Office Action Summary	Application No. 10/814,794	Applicant(s) SONG ET AL.	
	Examiner Philip Gabler	Art Unit 3637

DETAILED ACTION

McCollom '839 Figures 1-3

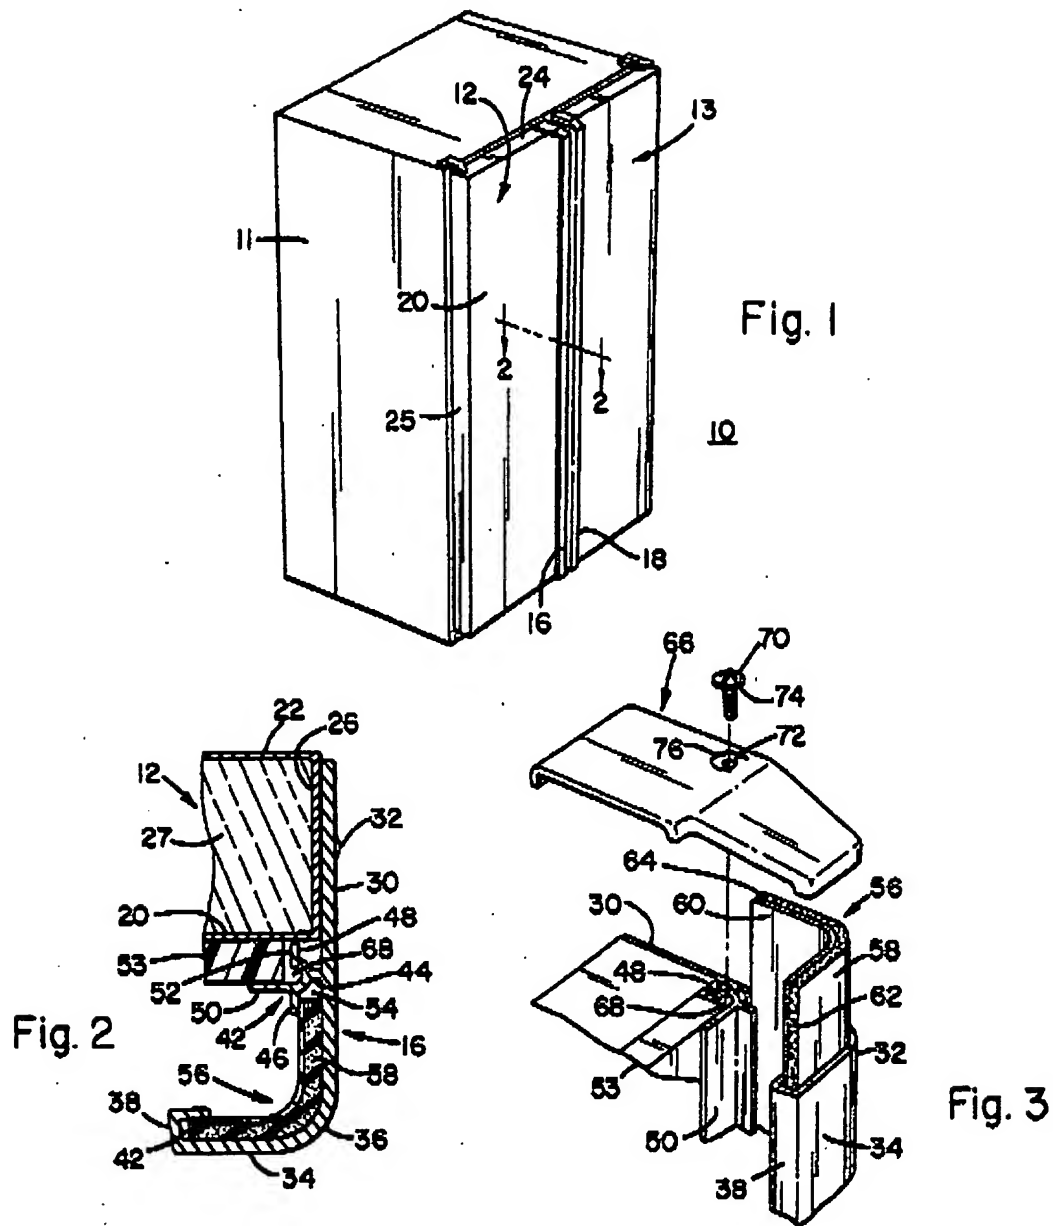
8. Claim 1 is rejected under 35 U.S.C. 102(b) as being anticipated by McCollom (US Patent Number 5412839). McCollom (Figures 1-3) discloses a refrigerator (10) comprising: doors (12, 13) for opening or closing storage chambers (in 11, see column 1 lines 59-62); door handles (16,18) respectively provided at the doors; buffer members (56) of an elastic material respectively provided for the door handles and capable of making good tactile sensations when gripping the door handles; and deviating prevention members (66) capable of preventing the buffer members from being deviated from the door handles.

Exhibit 1: Roberts et al. ‘349 Figures 1, 2, and 5

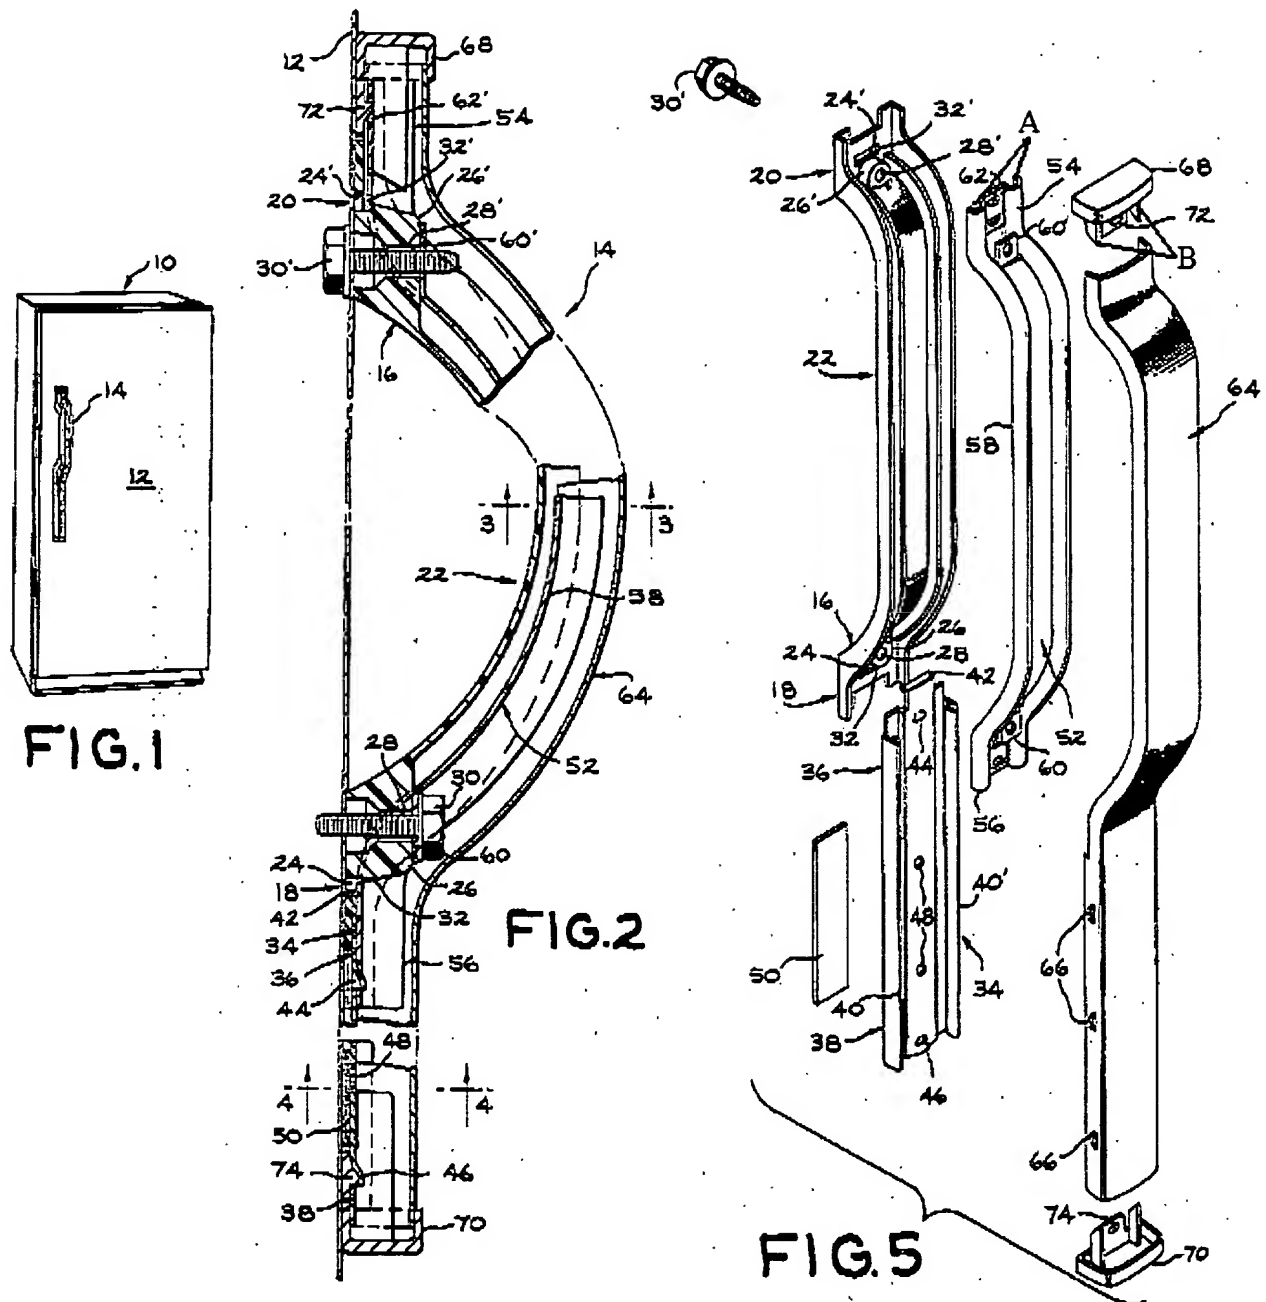
10. Claims 2, 3, 5, and 6, as best understood, are rejected under 35 U.S.C. 103(a) as being unpatentable over McCollom in view of Roberts et al. (US Patent Number 3995349). McCollom discloses a refrigerator as recited in claim 1 including handles comprising: a fixing portion (30) fixed to a free end of the door; a front extension (portion of handle between 30 and 36), which extends in a front direction of the door from the fixing portion; a side extension (34, 36), which is bent to extend from an end of the front extension toward a center of rotation of the door; and an insertion groove (42) formed at an inner surface of the side extension for inserting the buffer member. McCollom does not disclose a deviating prevention member located in the insertion groove. Roberts (Figures 1, 2, and 5) discloses a refrigerator (10) with a handle (14) including a deviating prevention member (68) fitting in insertion grooves (viewed in Exhibit 1 as the grooves A of element 52 that receive portions B of 68). Accordingly, it would have been obvious to one of ordinary skill in the art at the time the invention was made to modify McCollom's handle to include a deviating prevention member fitting in an insertion groove as taught by Roberts because this arrangement would better secure the buffer member.

12. Regarding claims 5 and 6, McCollom, when modified by Roberts as described above, discloses a refrigerator as recited in claim 3 but does not disclose a fixing protrusion and an elastic deformation portion. Roberts however, further discloses the deviating prevention member is provided with a fixing protrusion (72) for fixing the deviating prevention member in an insertion groove, and a mating member is formed with a fixing groove (62) for the fixing protrusion to be inserted into; and the deviating prevention member is slidably supported, at opposite sides thereof, in the insertion groove (elements B supported in A), and provided at a center thereof, with an elastic deformation portion (portion surrounding 72), which can deform such that the fixing protrusion can be vertically varied. Accordingly, it would have been obvious to one of ordinary skill in the art at the time the invention was made to further modify McCollom's handle to include a fixing portion and an elastic deformation portion on the deviating prevention member as taught by Roberts because this would allow the deviating prevention member to be secured in the handle assembly.

DeVoe et al. '195 Figures 1 and 5

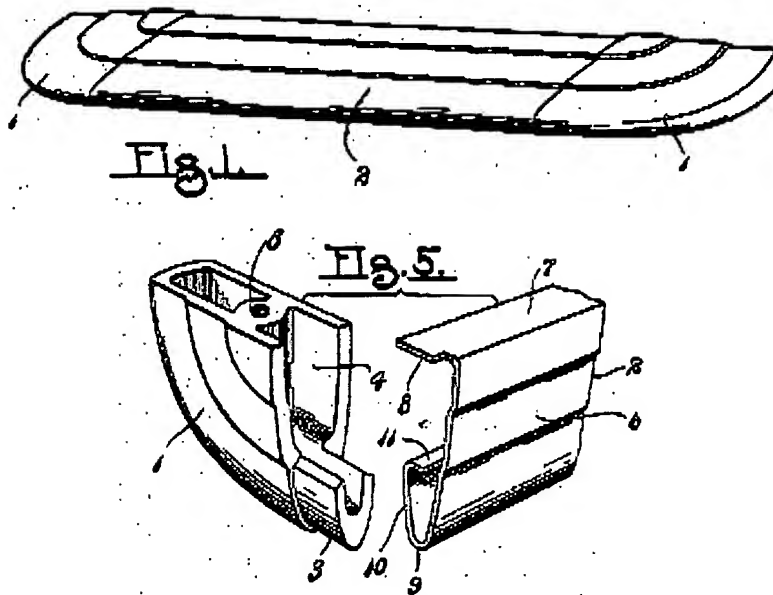
13. Claims 4 and 7, as best understood, are rejected under 35 U.S.C. 103(a) as being unpatentable over McCollom in view of Roberts and further in view of DeVoe et al. (US Patent Number 2151195). McCollom, when modified by Roberts as described above, discloses a refrigerator as recited in claims 3 and 6 but does not disclose a buffer member or deviating prevention member formed with an uneven portion. DeVoe (Figures 1 and 5) discloses an appliance handle with a gripping member (2) formed with an uneven surface and deviating prevention members (1) formed with the same uneven surface. Accordingly, it would have been obvious to one of ordinary skill in the art at the time the invention was made to modify McCollom's handle, previously modified by Roberts, to include uneven portions on the buffer and deviating prevention members as taught by DeVoe because this arrangement would provide a better grip on the handle for the user.
